PROJECT: VARIETY SCHOOL

CITY OF LAS VEGAS		DATE:
INTER-OFFICE MEMORANDUM		August 16, 2011
TO: Land Development Services Department of Public Works		FROM: Albert Sung, P.E. Flood Control Project Engineer Department of Public Works
SUBJECT:	Drainage Study for: Variety School	COPIES TO: Slater Hanifan Group
Cross Streets:	SEC Stewart Avenue & 28 th Street	Clark County School District
File Number:	F:\Depot\DSMemos\DS4535A.doc	Bart Anderson, P.E., DevCo
Parcel Number:	139-36-303-001	
Zoning Action:	SDR-42251	
FEMA Flood Zone	YES NO X	
Proposed Storm Drain	YES NO X

TECHNICAL DRAINAGE STUDY

Variety School

STW (100-YR) Worksheet for Irregular Channel

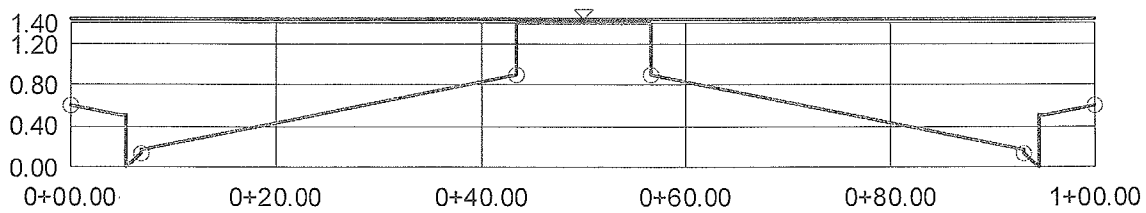
2. The anticipated 100-year flow depth in Stewart Avenue is 1.44' and the velocity is erosive. Per **Section Detail F/D-1**, a 7'-wide multi-use path will be totally inundated in the erosive flow during a major flood event. Provide a minimum 2'-high solid grouted stem wall (use 8"-CMU) at the back of the 5'-landscape for flood protection. Review and revise accordingly.
